Addendum 02
SFISD RJ Wollam Elementary School
& Santa Fe Junior High School
Generator Installation

18 April 2022

This addendum modifies the original Proposal Documents dated March 25, 2022 and forms a part of the Contract Documents. Acknowledge receipt of this Addendum in the space provided on the Proposal Form. Failure to do so may subject Proposer to disqualification.

MECHANICAL ENLARGED ROOF PLAN
1/4" = 1'-0"

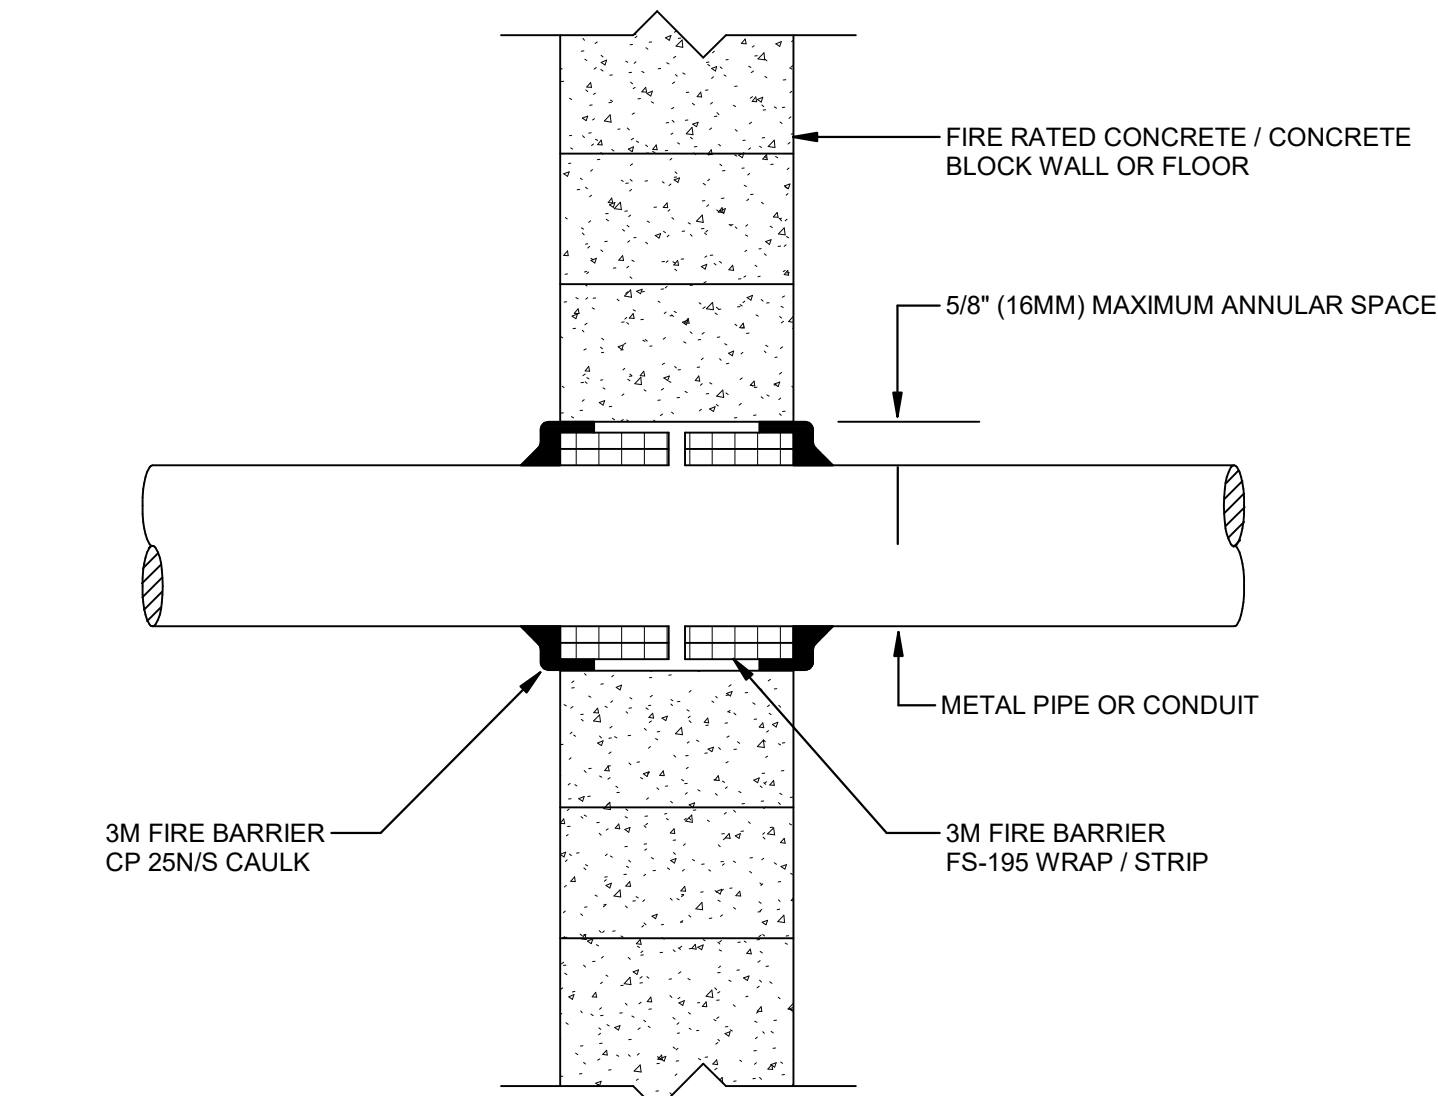
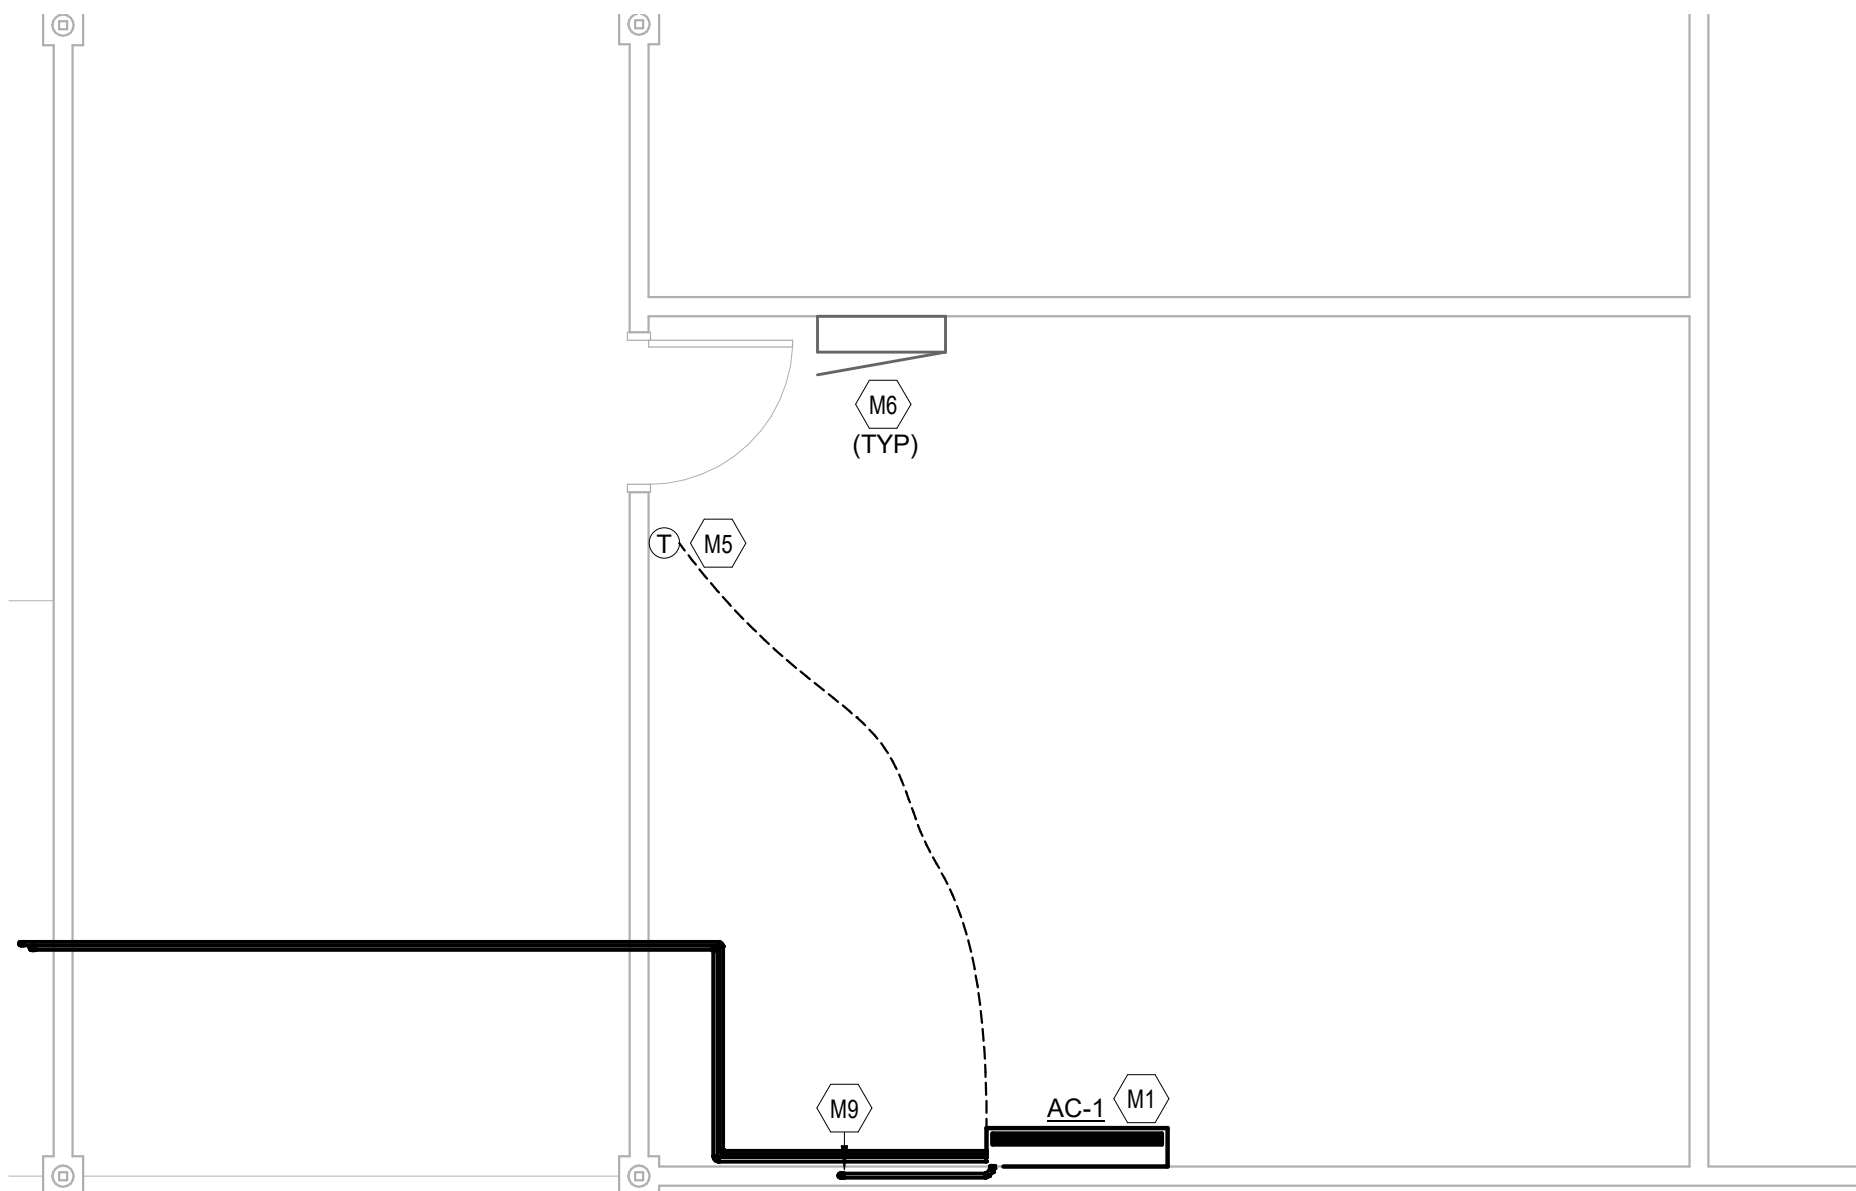
- 03 ES-M2.0 MECHANICAL ENLARGED ROOMS AND DETAILS:
 - a. Removed view 3/ES-M2.0 from the project and cooling towers VFD's is existing to remain.
 - b. Removed VFD's detail from the project as noted above and tagged note M8 accordingly.

ELECTRICAL
ONE-LINE
DIAGRAM - NEW
SCOPE

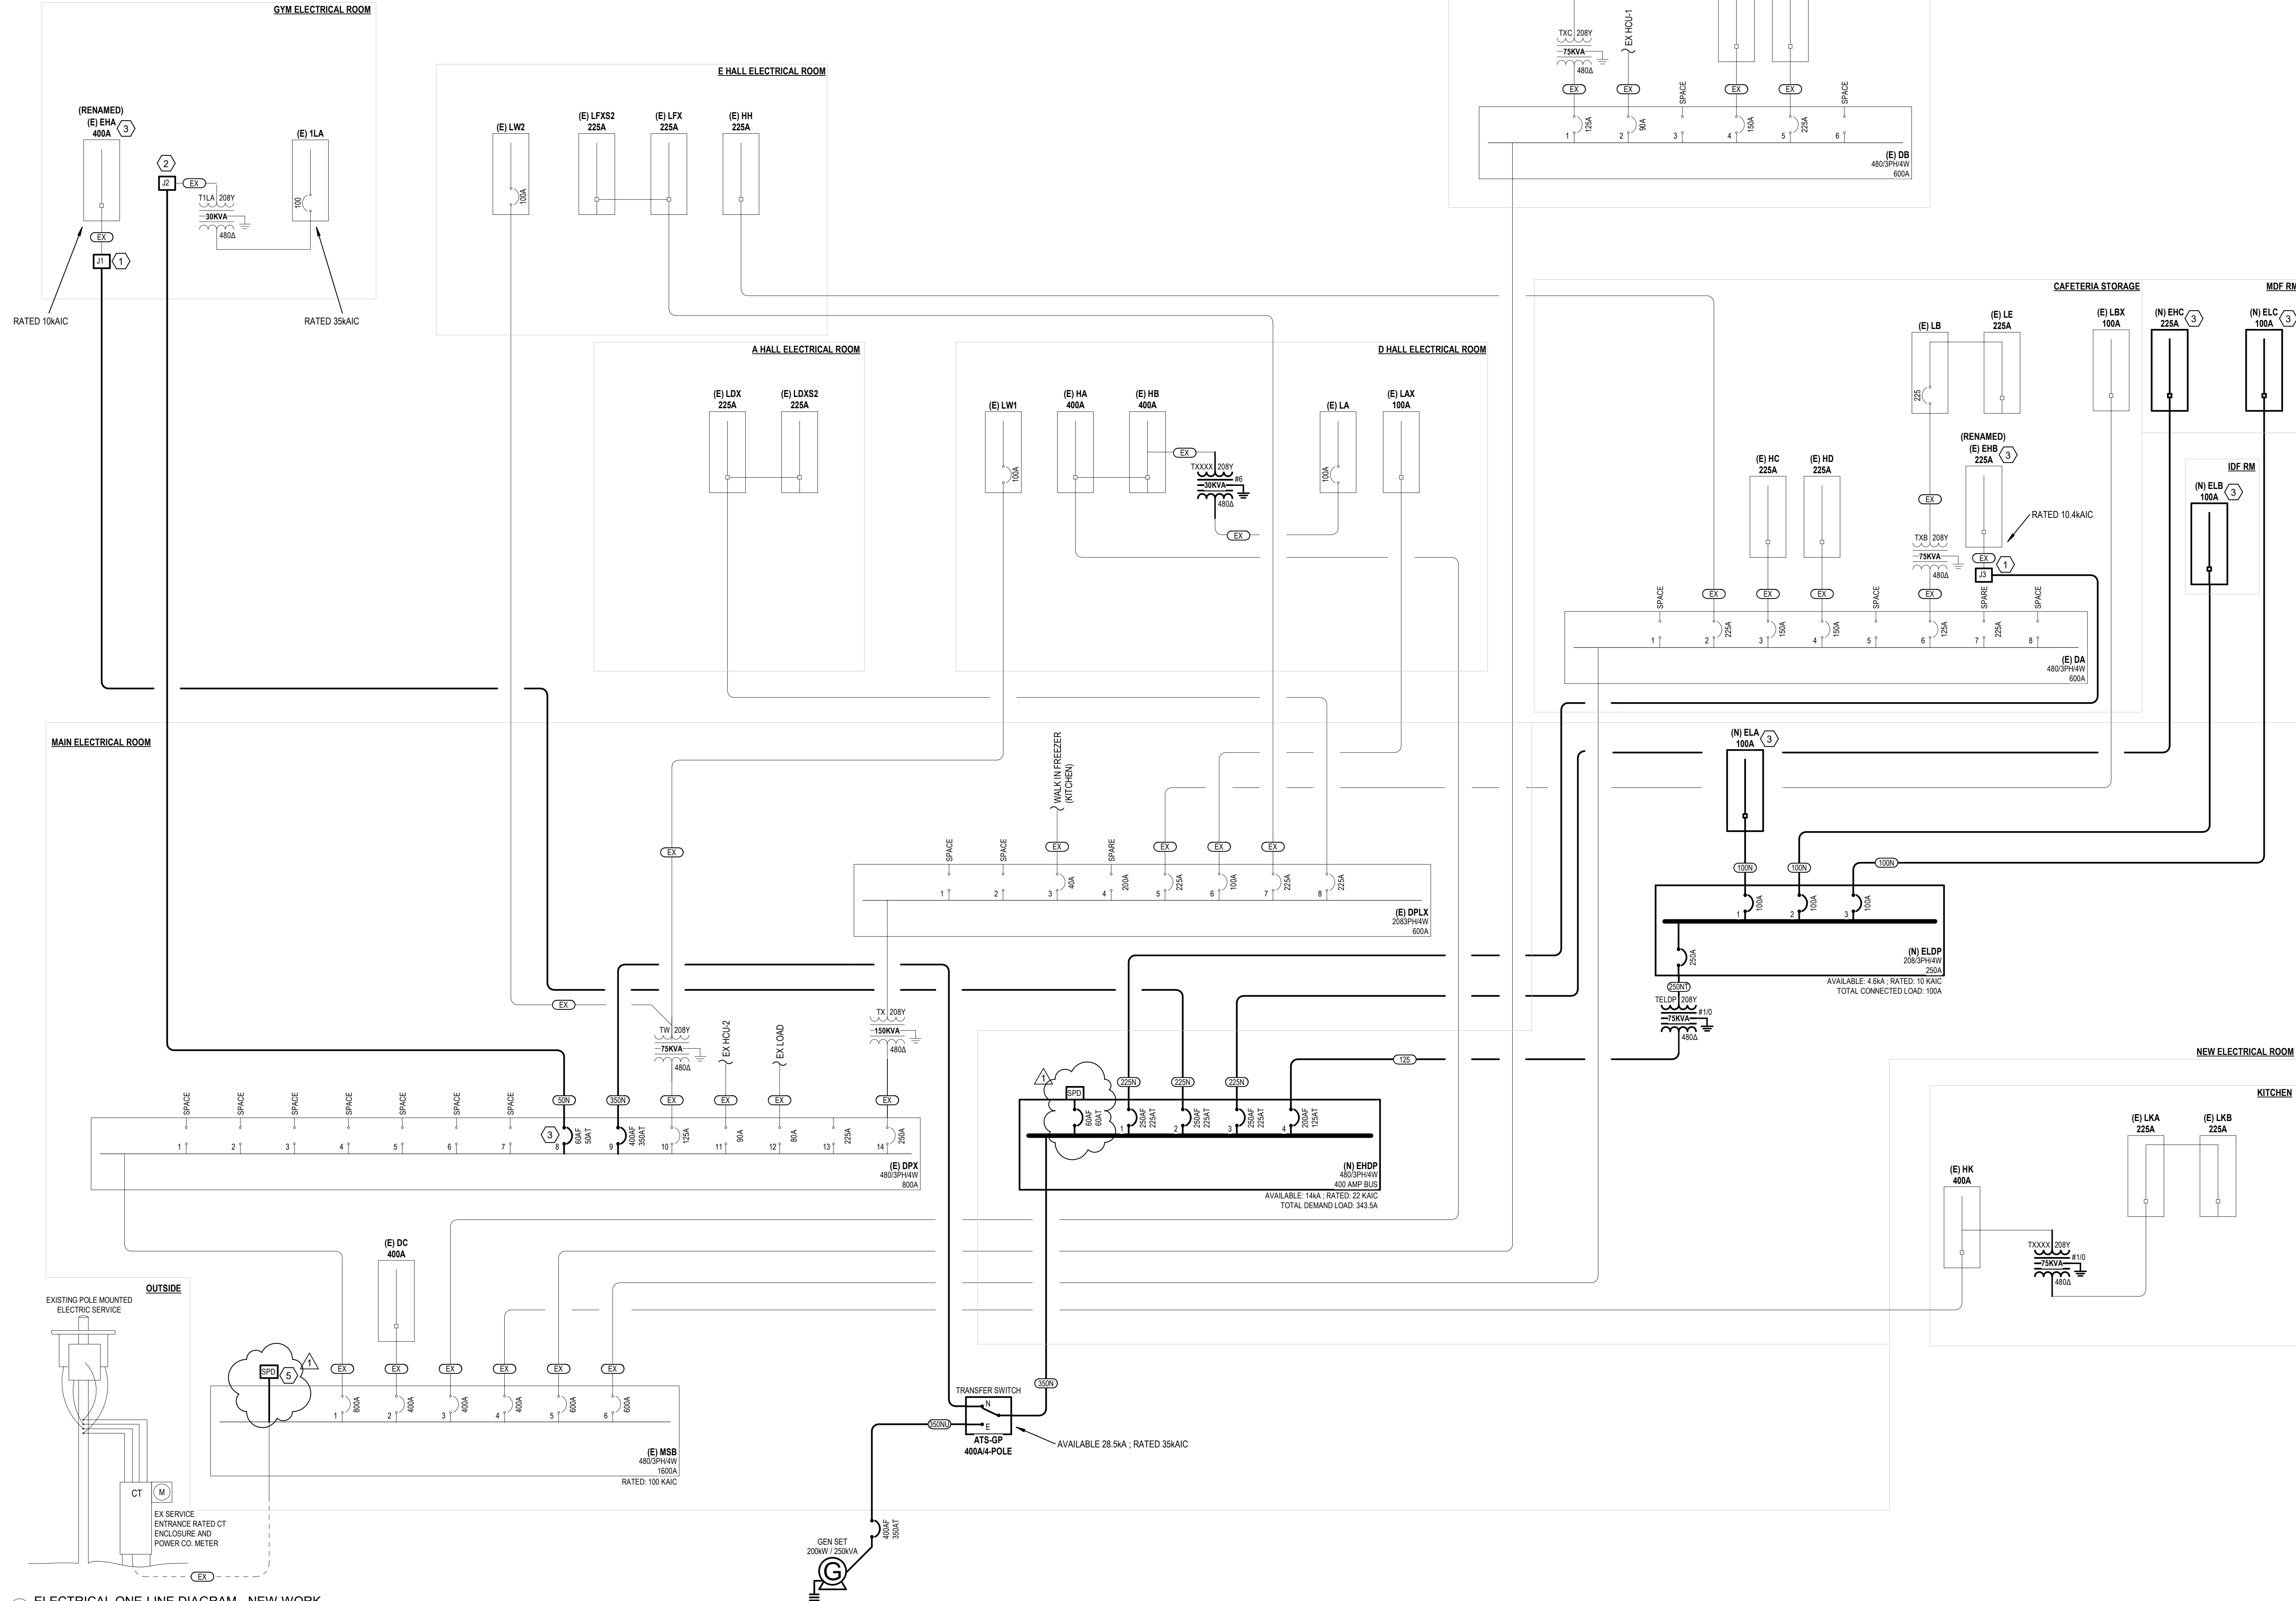
- 05 ES-E5.1 ELECTRICAL ONE-LINE DIAGRAM – NEW SCOPE:
 - a. Add new service entrance rated SPD at main service switchboard as an add alternate.
 - b. Add new SPD to new distribution panel 'EHDP'.

- NEW JUNCTION BOX INSTALLED ON WALL OF ELECTRICAL ROOM (SEE SHEET ES-5.01). EXTEND CONDUIT AND FEEDER FROM JUNCTION BOX OVERHEAD TO NEW EMERGENCY DISTRIBUTION PANEL EMDP AS INDICATED.
- NEW JUNCTION BOX INSTALLED ON WALL OF ELECTRICAL ROOM (SEE SHEET ES-5.01). EXTEND CONDUIT AND FEEDER FROM JUNCTION BOX OVERHEAD TO EXISTING NORMAL POWER DISTRIBUTION PANEL DPX AS INDICATED.
- INDICATES NEW CIRCUIT BREAKER. NEW CIRCUIT BREAKER SHALL BE INSTALLED ON EXISTING PANEL AS INDICATED.
- AS AN ADD-ALTERNATE, PROVIDE NEW SERVICE ENTRANCE SURGE PROTECTIVE DEVICE TO SWITCHBOARD PER SPECIFICATIONS.
